ADDITIONAL S75W AMENDMENTS 26.09.18:

**PROPOSED MIXED USE DEVELOPMENT**

47-50 THE ESPLANADE ETTALONG BEACH

AMENDED SUBMISSION			
Job no.	Drawing no.	Rev.	
J15304S2	DA 101	F

**1 LEVEL 6 FLOOR PLAN**  
1 : 200

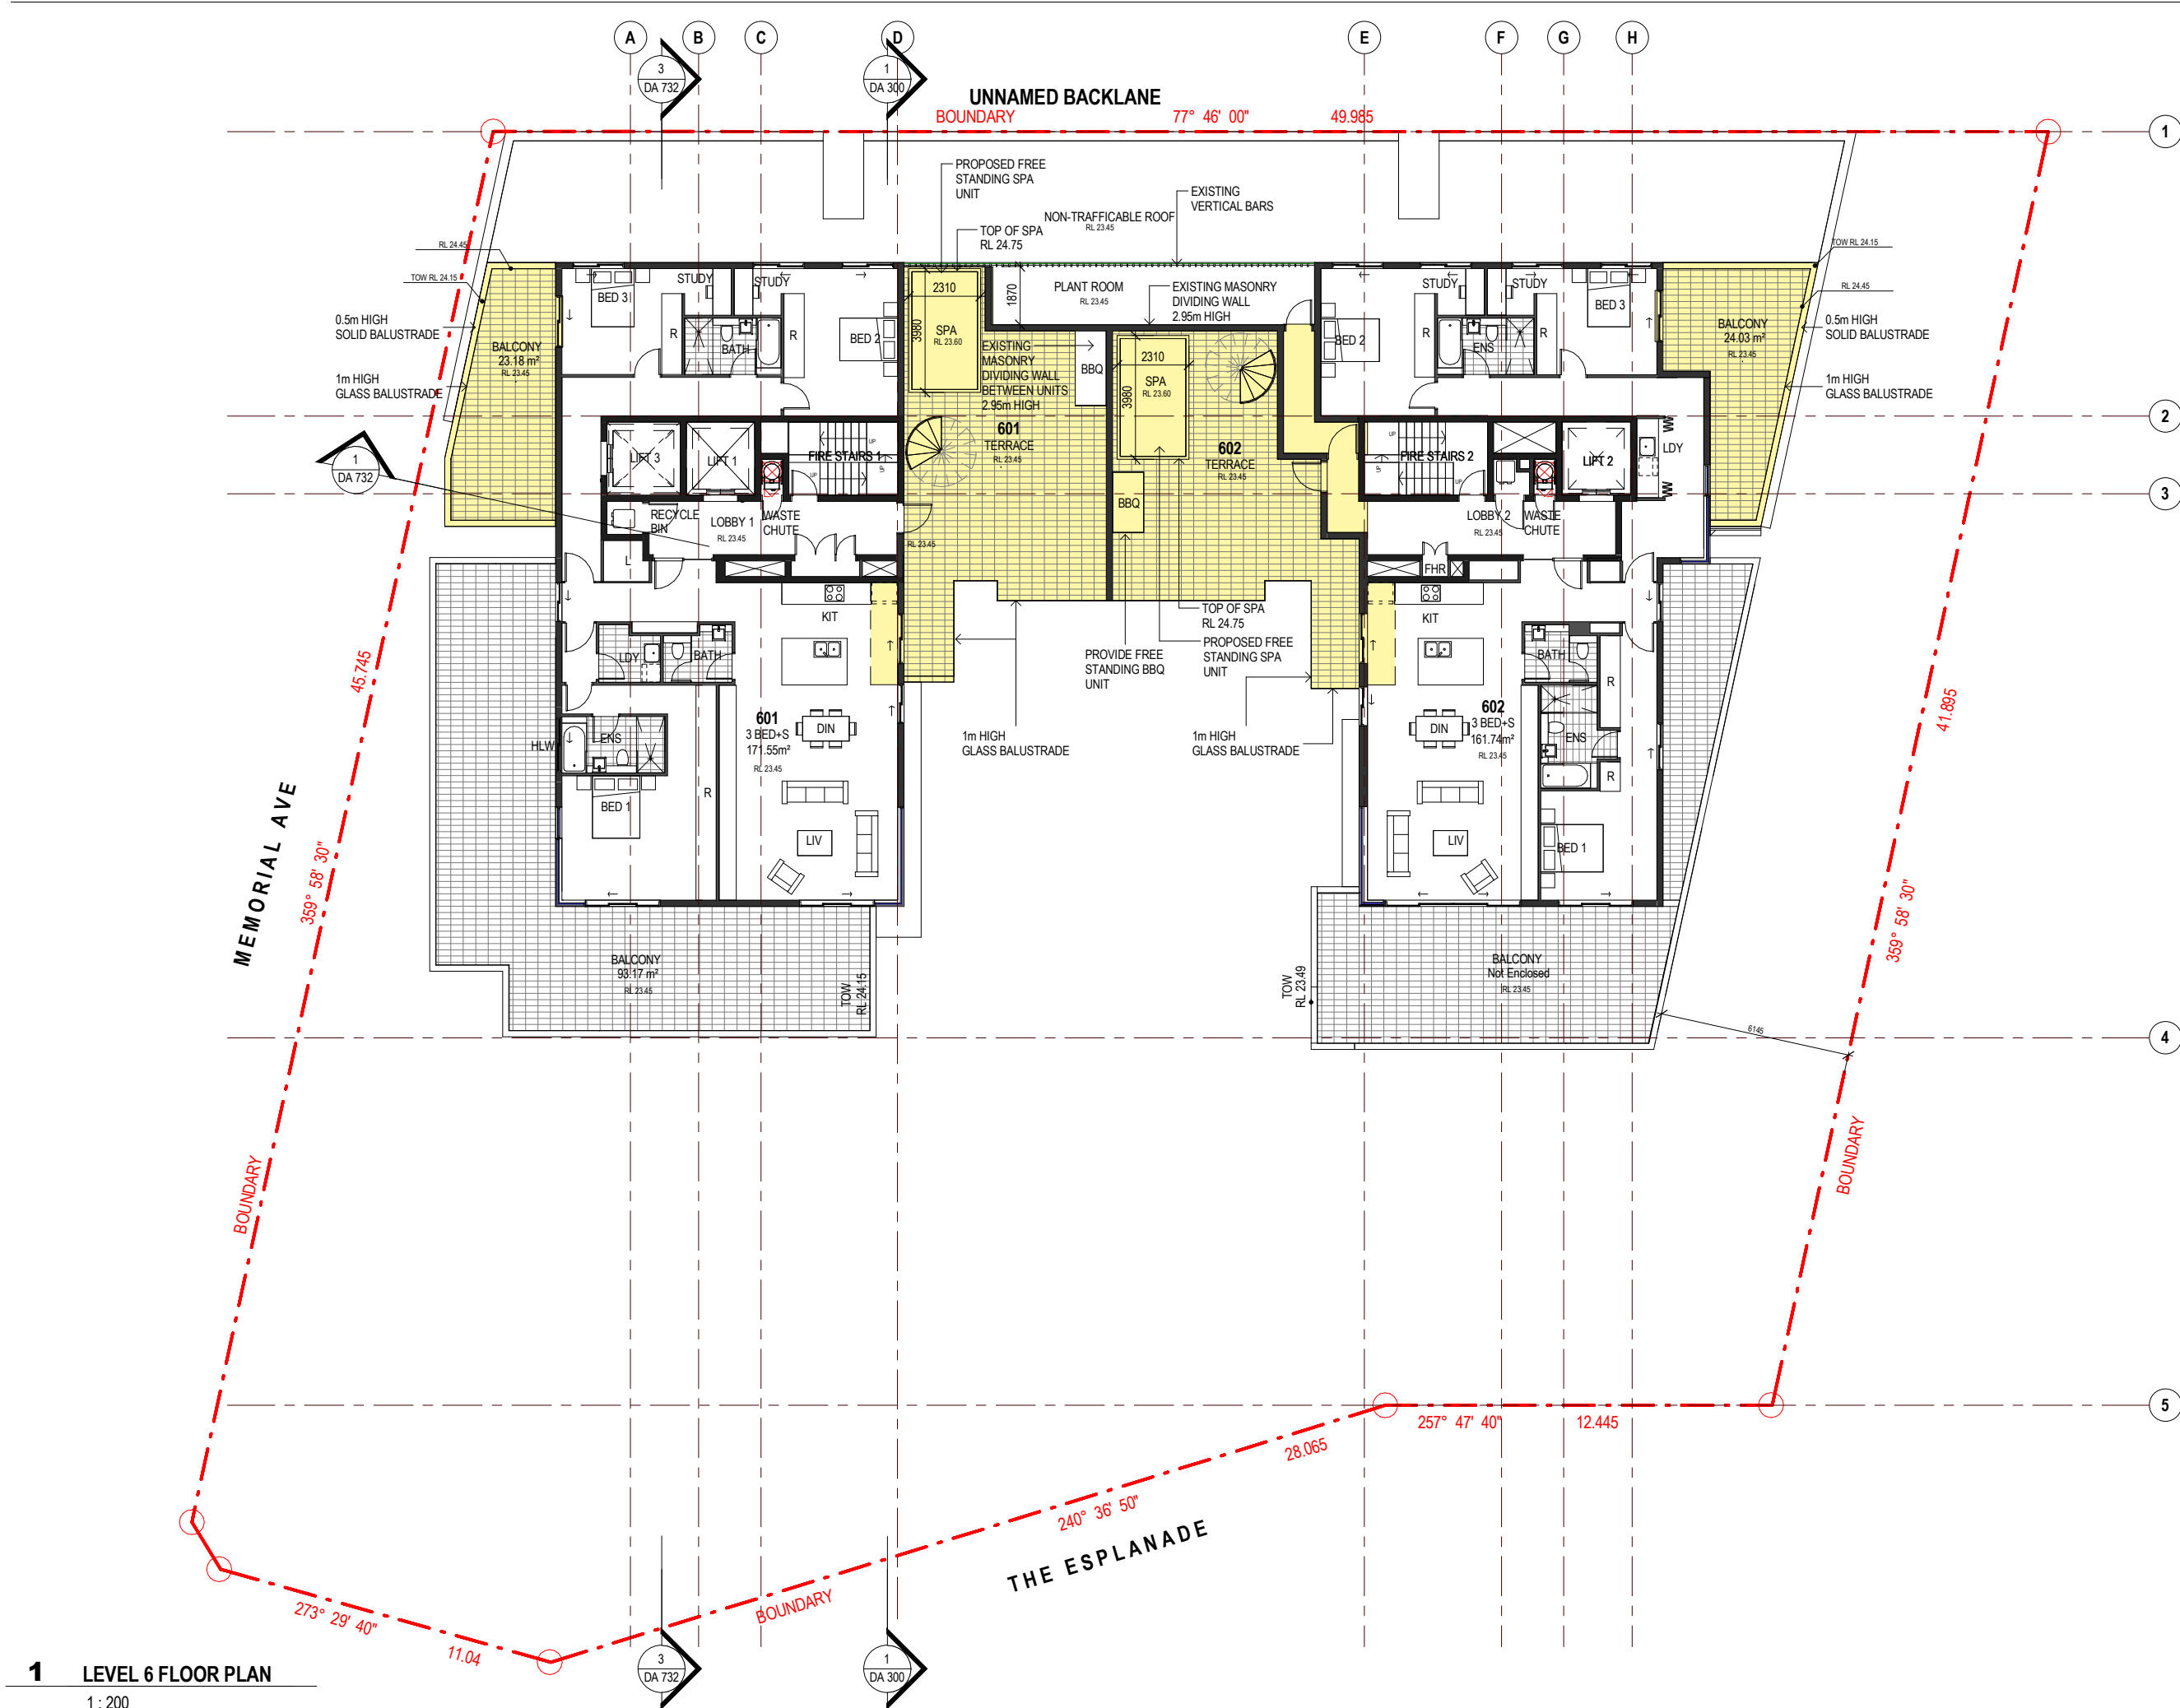
- ADDITIONAL S75W AMENDMENTS 26.09.2018:
- BALCONY PROVIDED TO BED 3 OF UNITS 601 & 602
  - PLANT ROOM AREA REDUCED
  - SPA RELOCATED IN TERRACE OF UNITS 601 & 602
  - SCREEN TO FRONT OF TERRACE OF UNITS 601 & 602 REMOVED
  - SPIRAL STAIRS PROVIDED IN TERRACE OF UNITS 601 & 602
  - NEW BALUSTRADE PROVIDED TO THE FRONT OF TERRACE OF UNITS 601 & 602
  - SLIDING DOOR PROVIDED TO KITCHENS OF UNITS 601 & 602
  - ISOLATED DOOR PROVIDED TO KITCHENS OF UNITS 601 & 602
  - ISOLATED ENTRY PLANT ROOM PROVIDED TO LOBBY 2

47-50 THE ESPLANADE ETTALONG BEACH  
Drawing Title  
**ROOF PLAN**

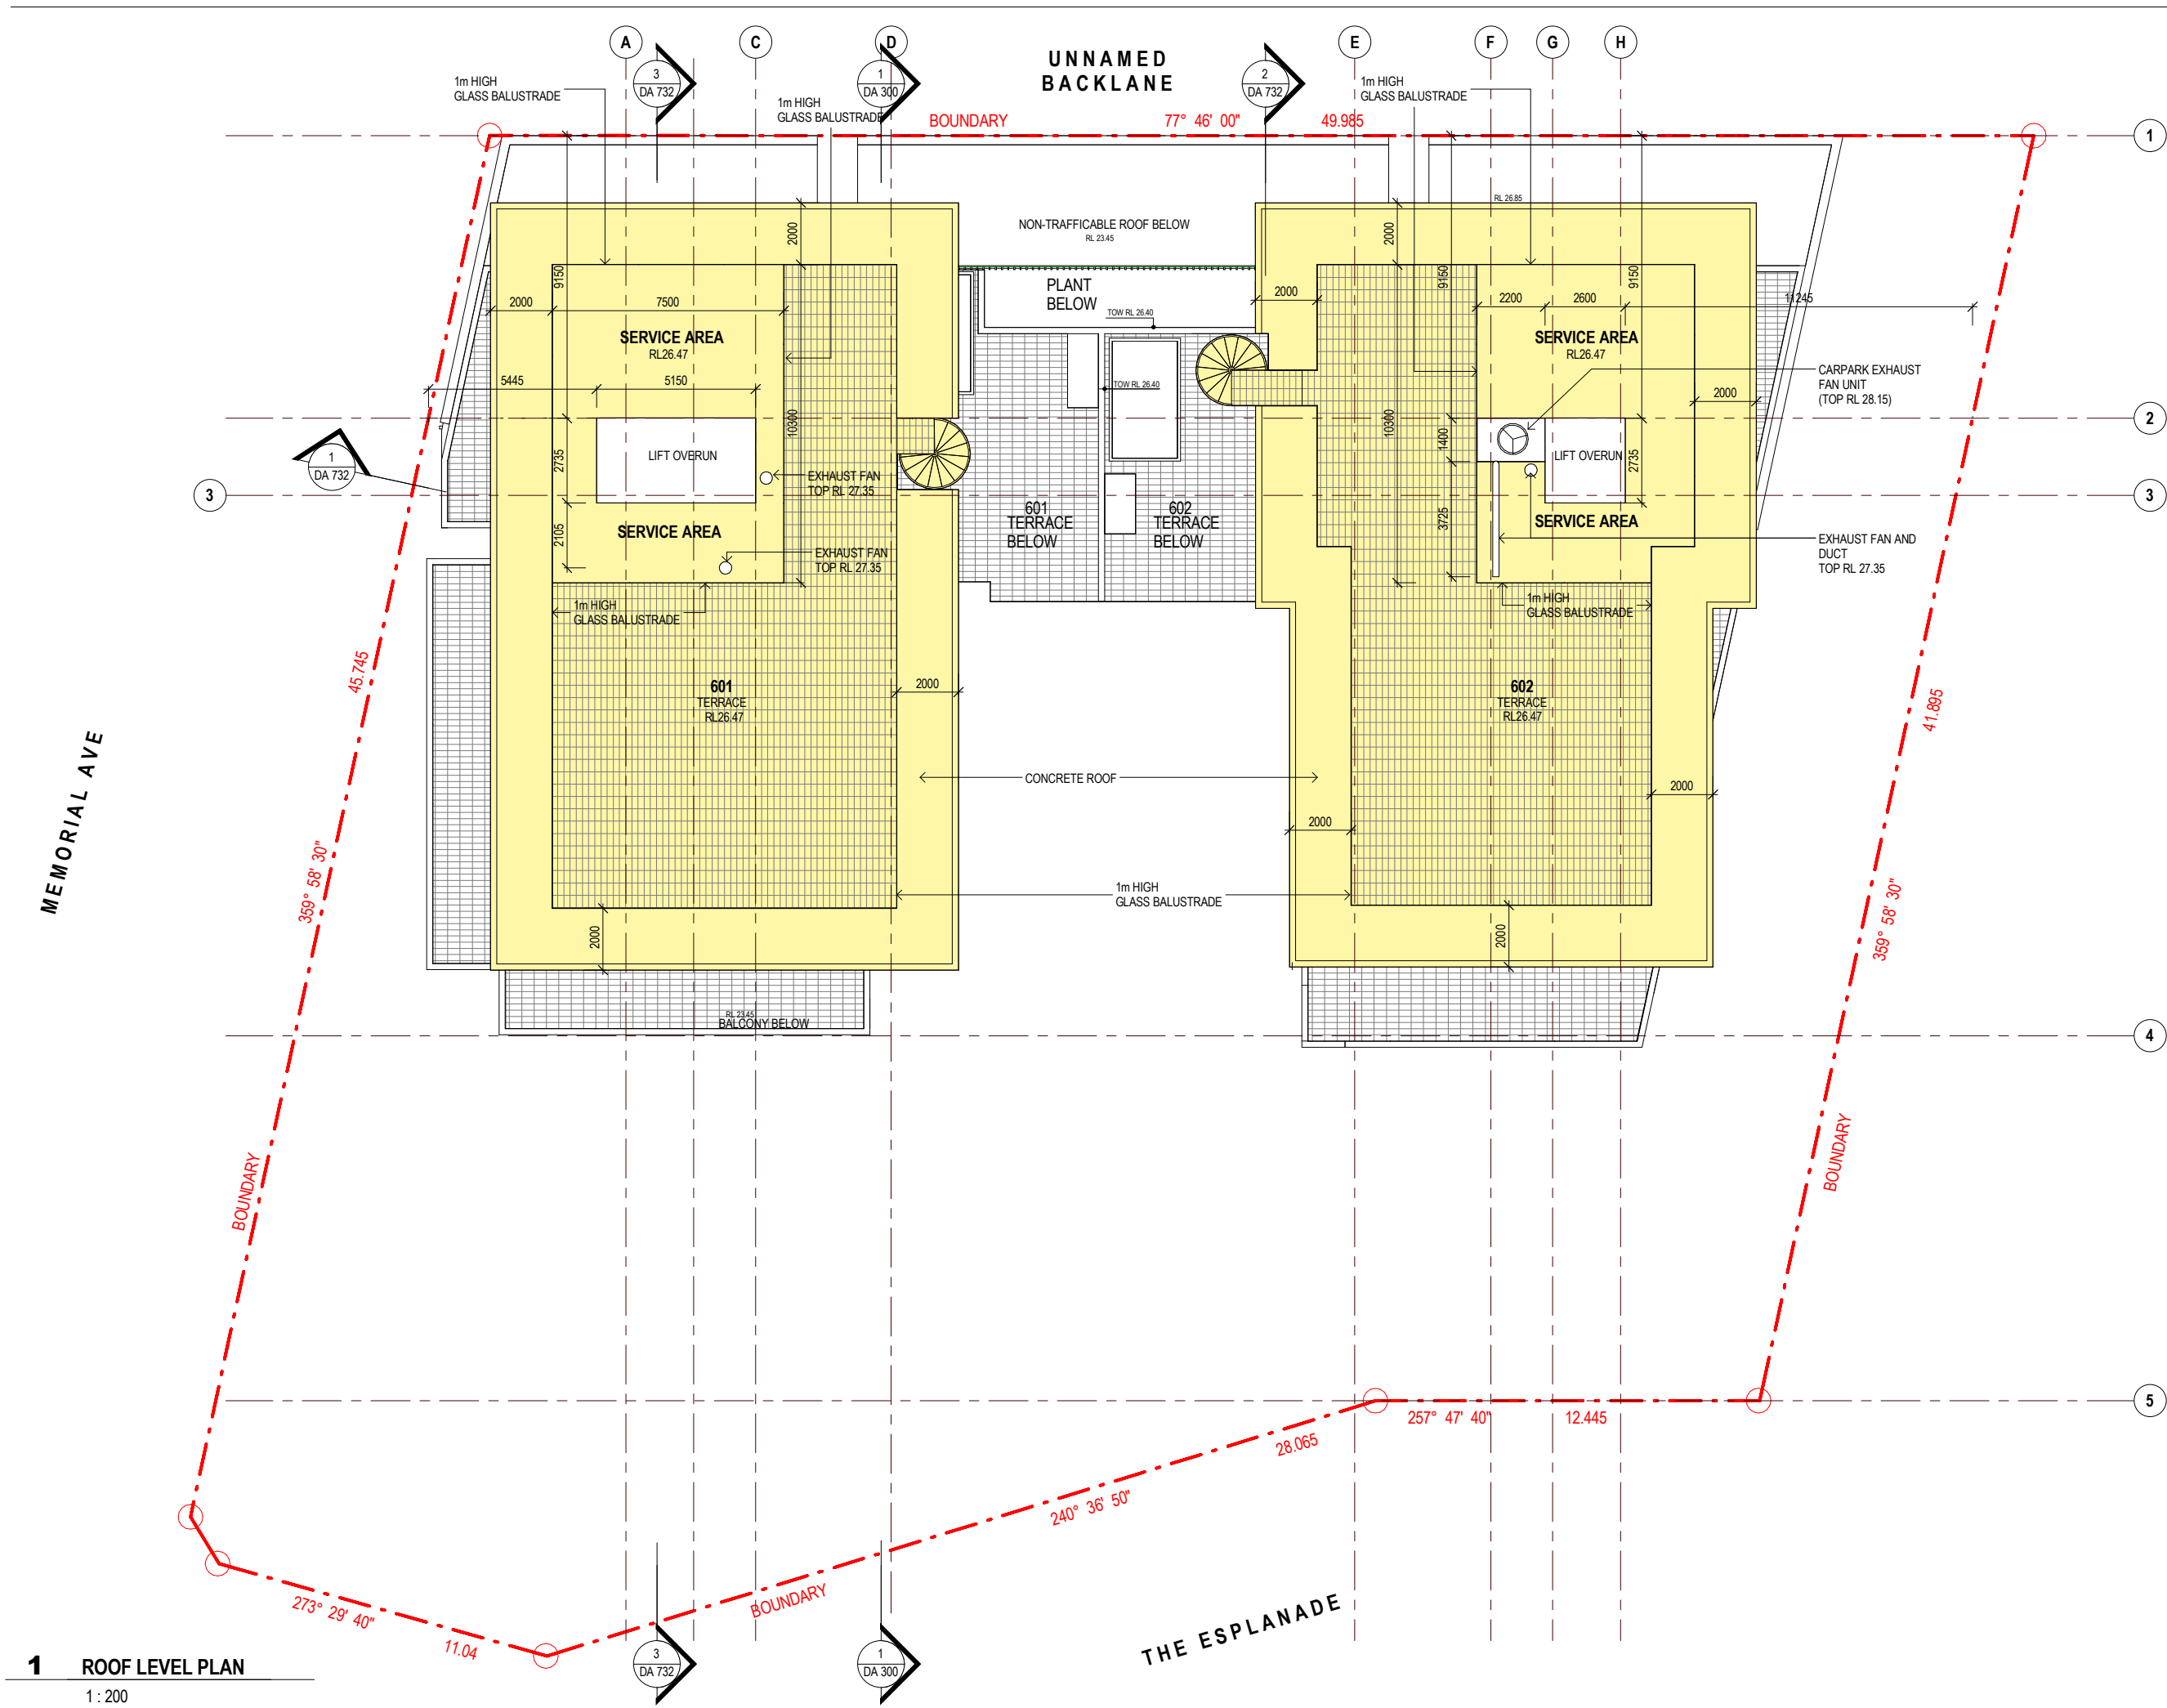
- ADDITIONAL S75W AMENDMENTS 26.09.2018:**
- ROOF OVER UNITS 601 & 602 MODIFIED TO BE FLAT CONCRETE SLAB
  - SERVICE AREAS OVER UNITS 601 & 602 PROVIDED AND NEW BALUSTRADE PROVIDED TO AREA
  - SPIRAL STAIRS PROVIDED TO ROOFS OVER UNITS 601 & 602
  - NEW 1m BALUSTRADE PROVIDED TO PERIMETER OF ROOFS
